**SERVICE BULLETIN**

**NUMBER:** 12-145-13R

**SUBJECT:** Condensation in Rear Combination Lamps, Retaining Nut and Sealing Gasket Change

**REVISED:** 04/17/13

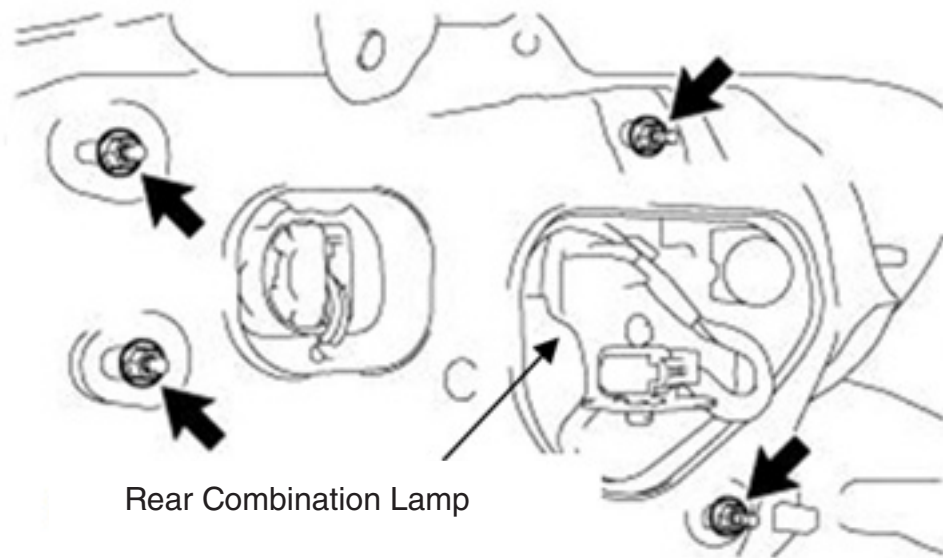
Due to a smaller diameter flange surface, the original retaining nuts may distort the rear body panel mounting and sealing surfaces for the combination lamps enough to allow moisture seepage past the seals into the combination lamps and possibly the trunk area. In addition, the thickness of the sealing gasket (packing) for the rear combination lamp has been increased from 5mm to 8mm.

Original Nut, 12mm diameter flange surface

Revised Nut, 15mm diameter flange surface

- The revised retaining nuts with a larger diameter flange surface were incorporated into production December 5th, 2012 starting with VIN D\*605847.
- The revised combination lamp sealing gaskets were incorporated into production February 1st, 2013 starting with VIN D\*607611.

### Example of crack

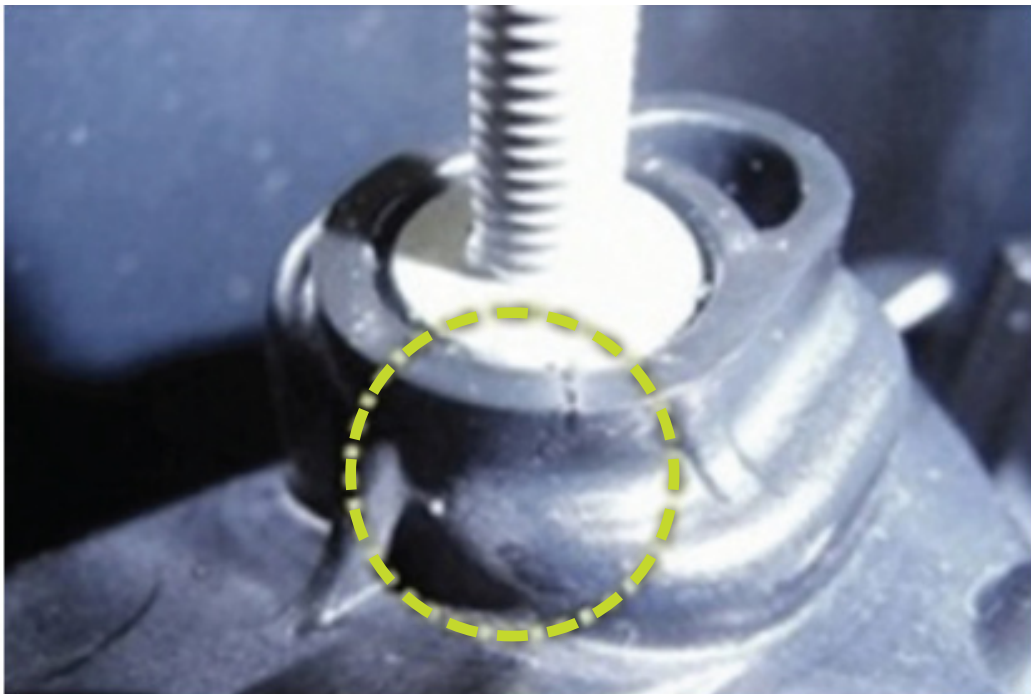
Once the combination lamps are removed, inspect their mounting stud boss areas carefully for any cracking as shown in the photo example below. Any damaged combination lamps must be replaced.

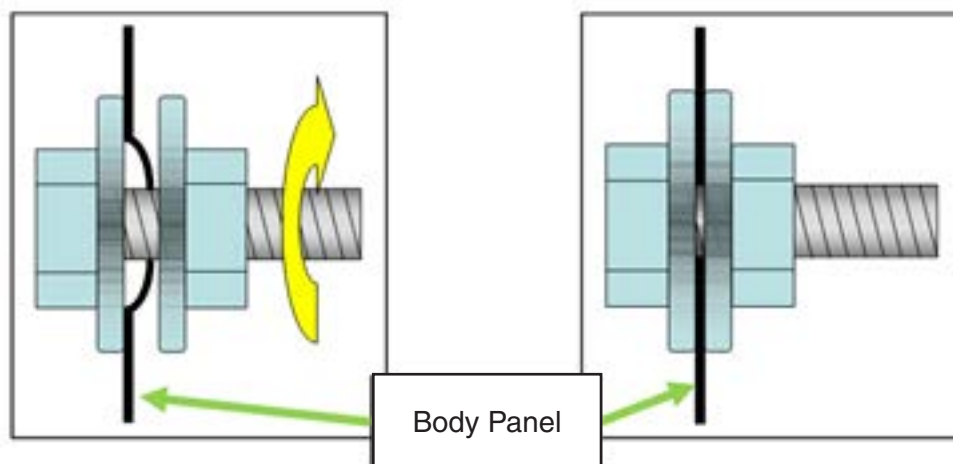
Inspect the rear body panel in the retaining nut areas for any deformation of the metal as shown in the illustrations below.

If any deformation is found, CAREFULLY straighten the affected mounting area using a small body hammer and dolly.

**L/H Sequence**

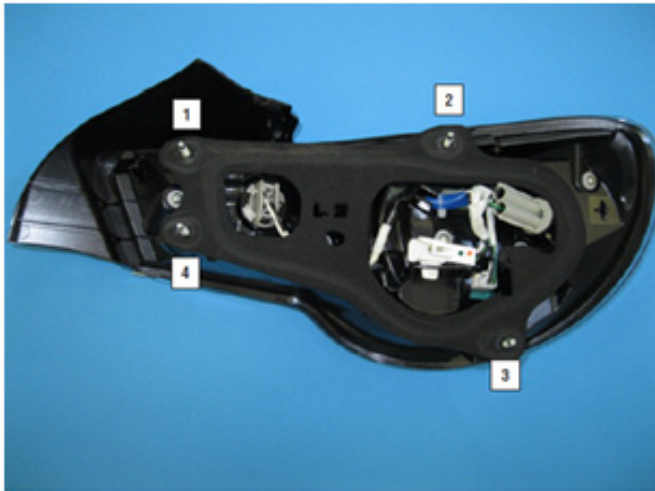
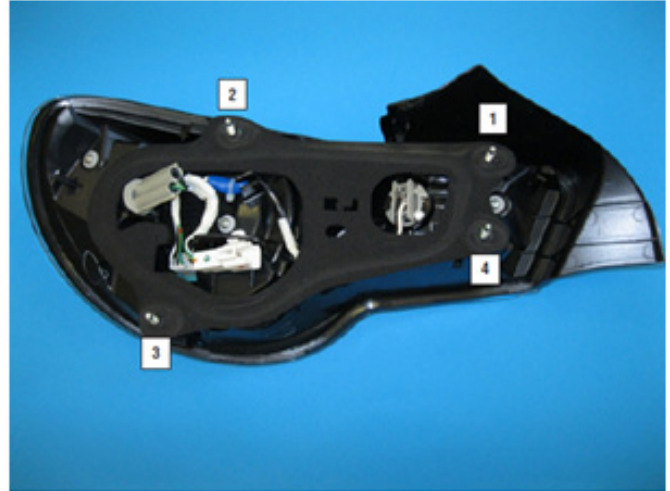
- Before reinstalling the tail combination assemblies, always install new sealing gaskets as they are one-time use items.
- The proper torque sequence must be followed as shown in the following illustrations or damage to the combination lamp assembly may result. The torque specification (unchanged) for the retaining nuts is 4.5 Nm (39 inch-pounds).
